## 4 Masterplan & Public Realm

# 6 Comparison Drawings

The following pages contain a series of comparison drawings to allow the amended design changes to be reviewed directly alongside the original approved planning drawings.

6.2.4 First Floor Plan

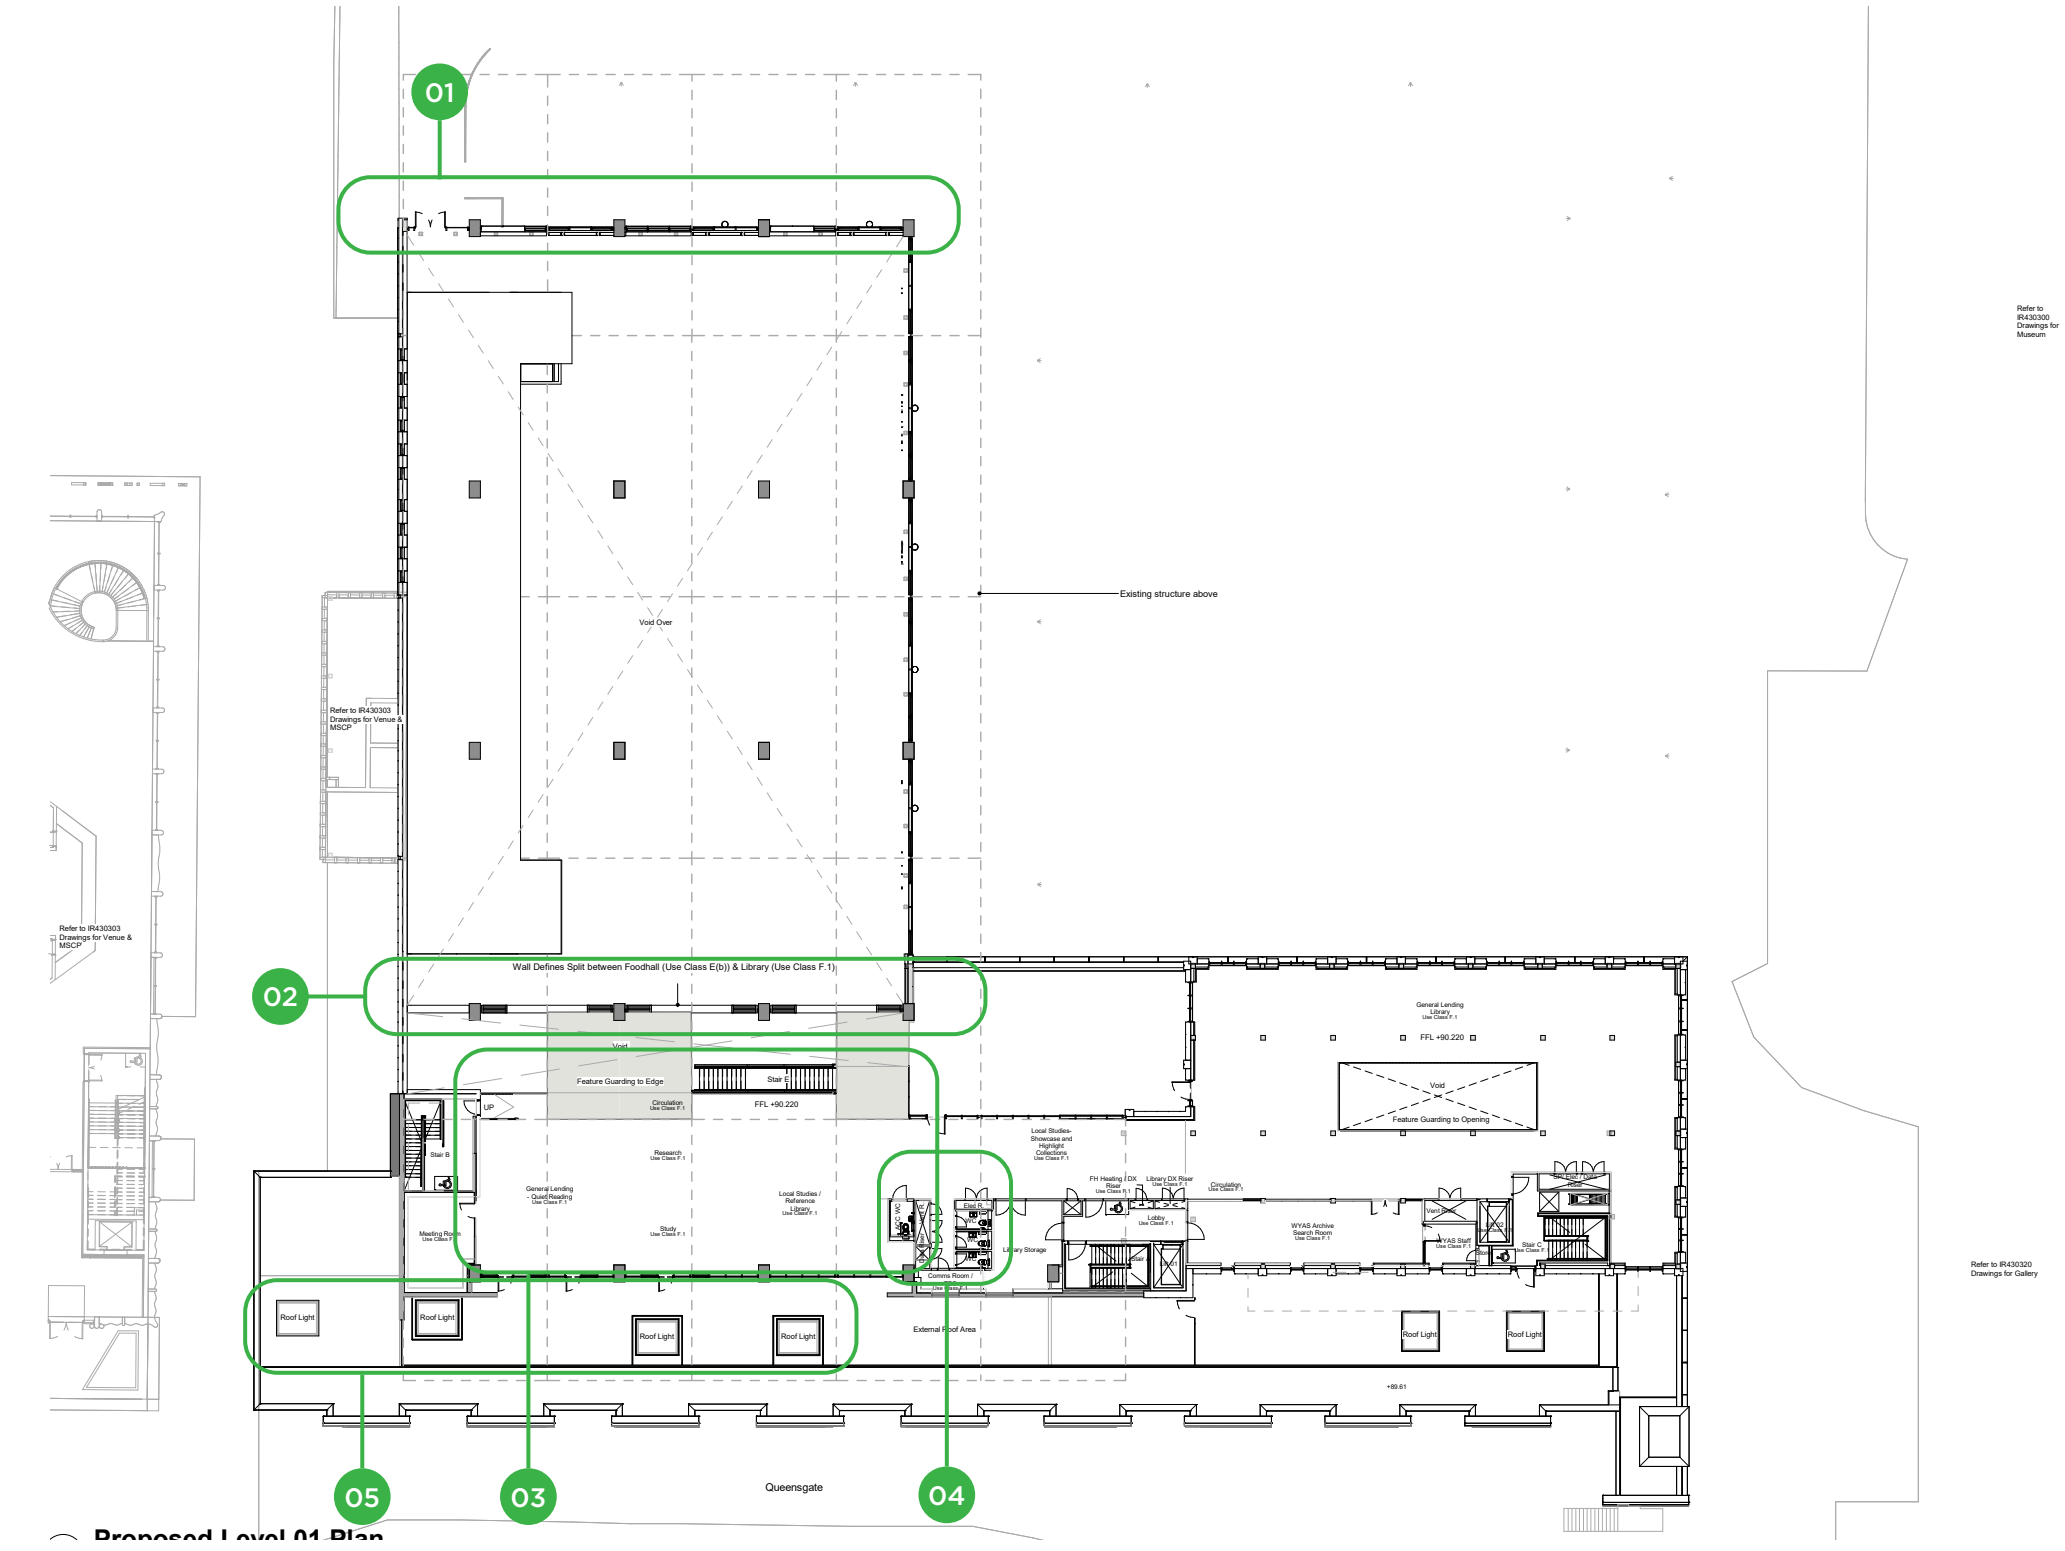
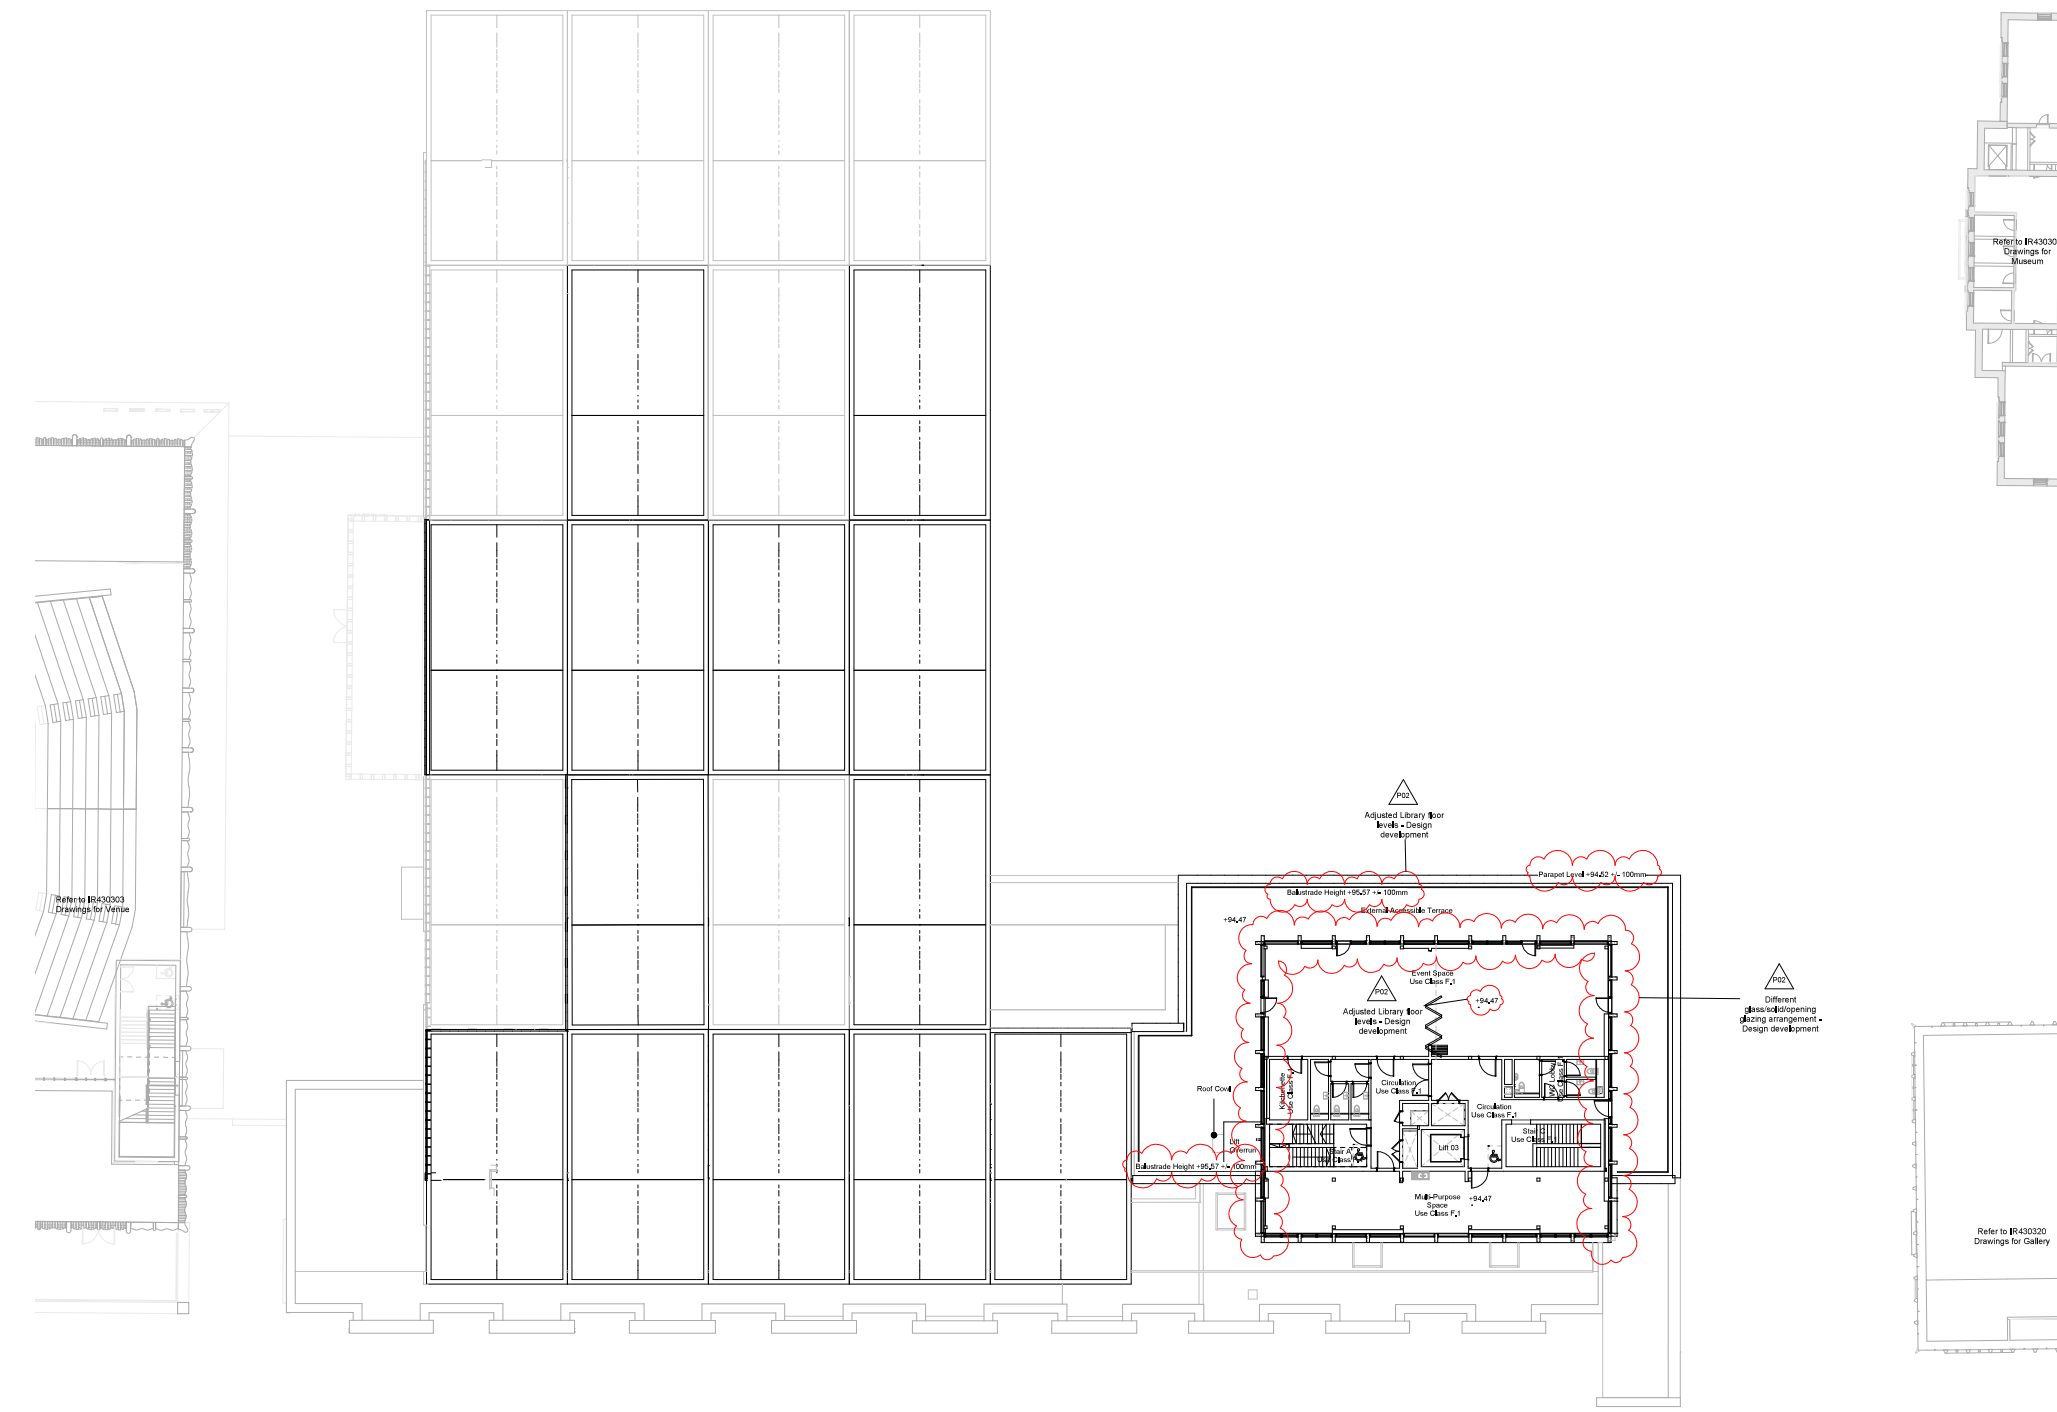
- 01 Introduction of solid cladding to west elevation of Food Hall.
- 02 Introduction of solid wall with fire rated windows instead of fire rated curtain wall glazing.
- 03 Relocation of cellular rooms under concrete roof.
- 04 Omission of one internal lift in library.
- 05 Introduction of additional roof lights to terrace slab.
